Change Order, Construction Manager as Adviser Edition

PROJECT: <i>(name and address)</i> Central Hardin High School Admn/Renov Cecilia, KY OWNER: <i>(name and address)</i> Hardin County Board of Education 65 W A Jenkins Road Elizabethtown, KY 42701	CONTRACT INFORMATION: Contract For: 100-01 PO Specialties Date: July 14, 2021 ARCHITECT: <i>(name and address)</i> JRA Architects 3225 Summit Square Place, Suite 200 Lexington, KY 40509	CHANGE ORDER INFORMATION: Change Order Number: 095 Date: January 10, 2024 CONSTRUCTION MANAGER: <i>(name and address)</i> Alliance Corporation 116 E. College Street Glasgow, KY 42141
CONTRACTOR: <i>(name and address)</i> Schiller Hardware 11525 Blankenbaker Access Drive Louisville, KY 40299

Proposal Request

Subject: CHHS COP 57 – (2) Privacy Screens

WRESTLING LOCKER ROOM

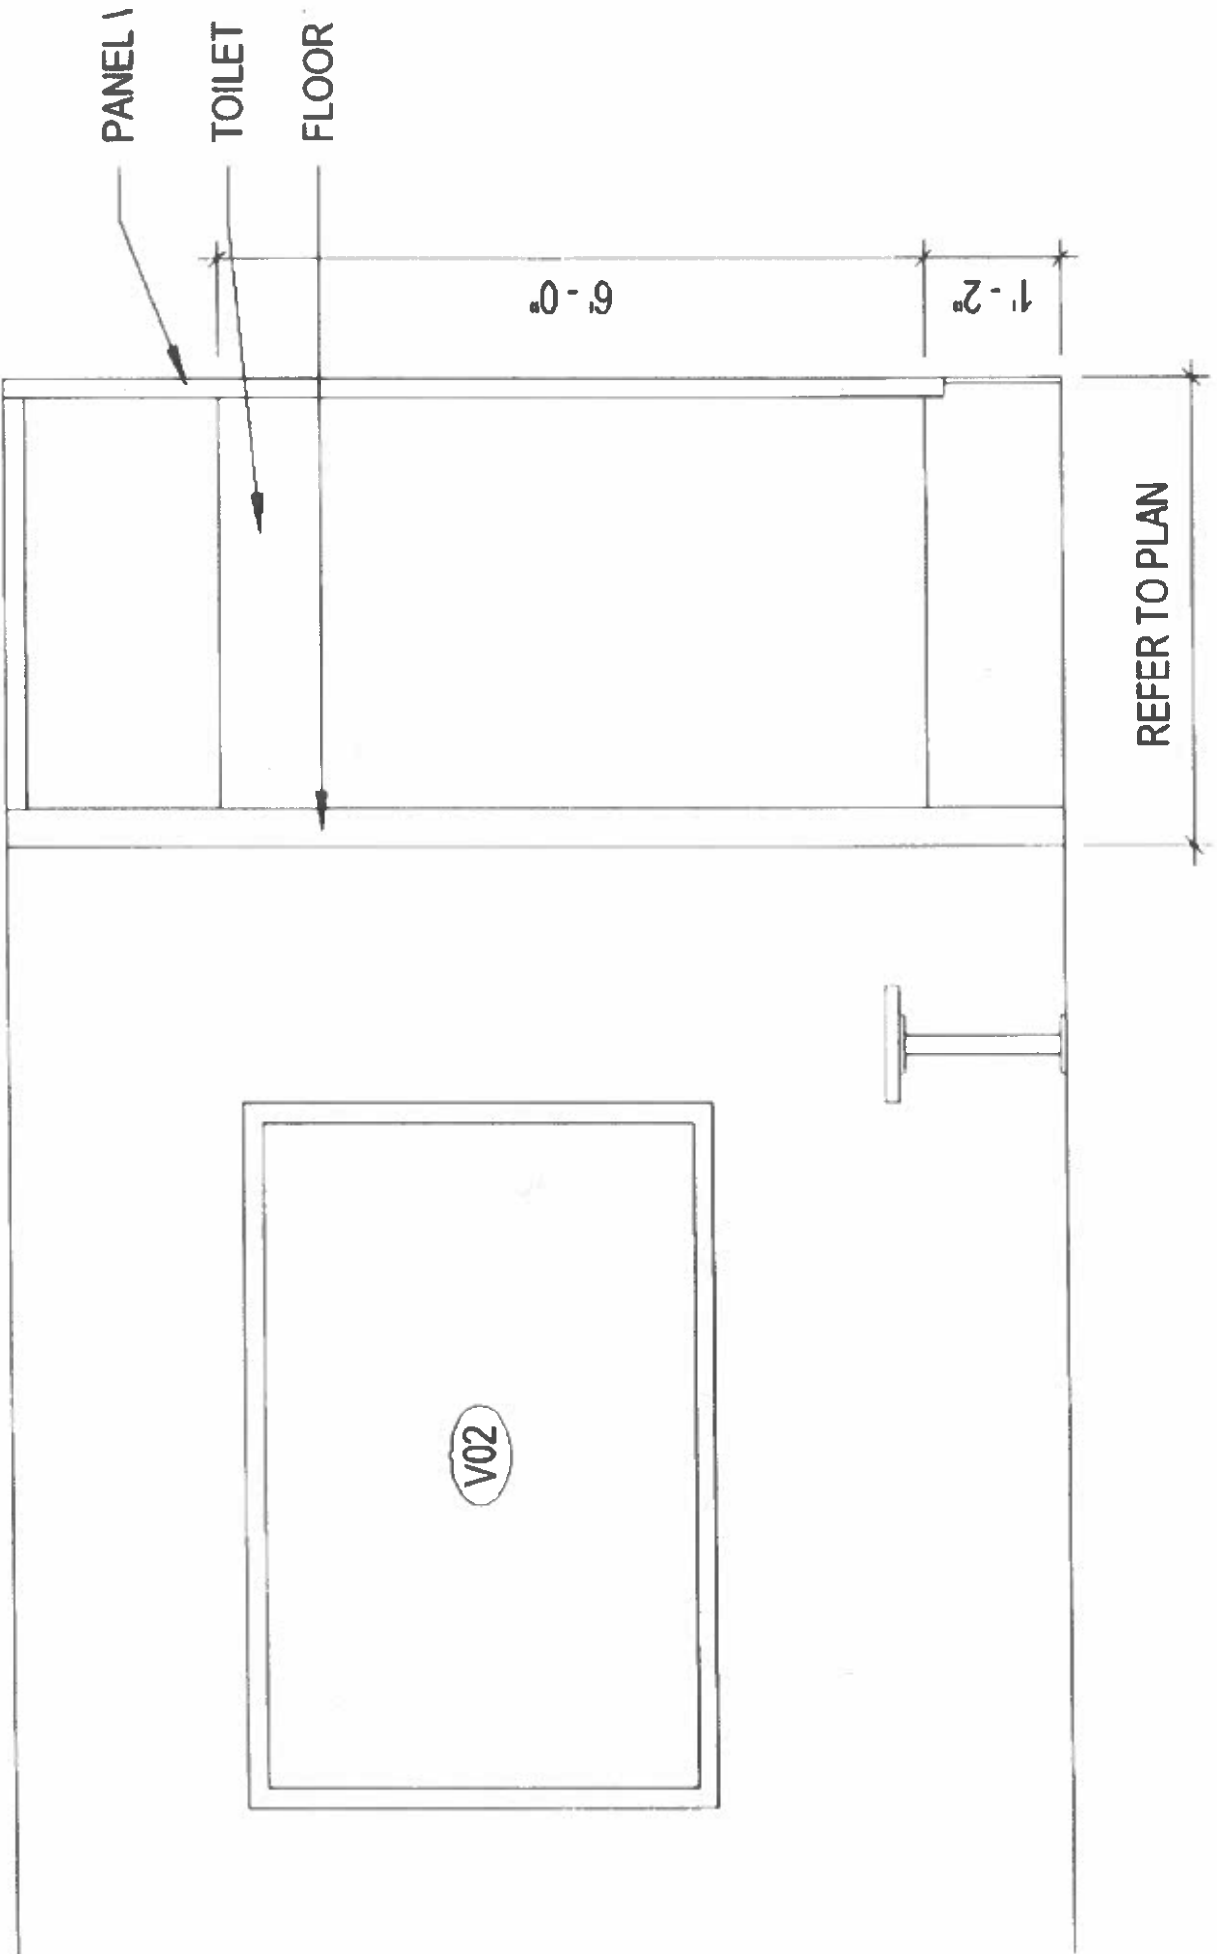
Provide two (2) privacy screens of the sizes indicated on the attached sketches. Refer to Specification Section 102113.19 Plastic Toilet Compartments for the requirements. Provide solid, high-density polyethylene (HDPE) panel material, not less than 1 inch thick, seamless, with eased edges, and with homogenous color and pattern throughout thickness of material. Provide full height attachment channels for wall and pilaster attachment. Run pilasters from floor to ceiling. Attach pilaster to floor with SS shoes and to ceiling with SS caps.

Please Note: if you want these to match the partitions you have, the floor to ceiling option is floor to ceiling with a post (not a pilaster). The largest floor to ceiling privacy screen is 46"x55". Requested sizing not available. Lastly, Continuous channels on walls is not available.

Please Note: I informed Joe Jones that I am able to supply the privacy screens with continuous channels and pilasters (as requested). The two size screens I am providing from Joe's conversation's are as follows.

(1) 40"x55" Screen

(1) 46" x55" Screen
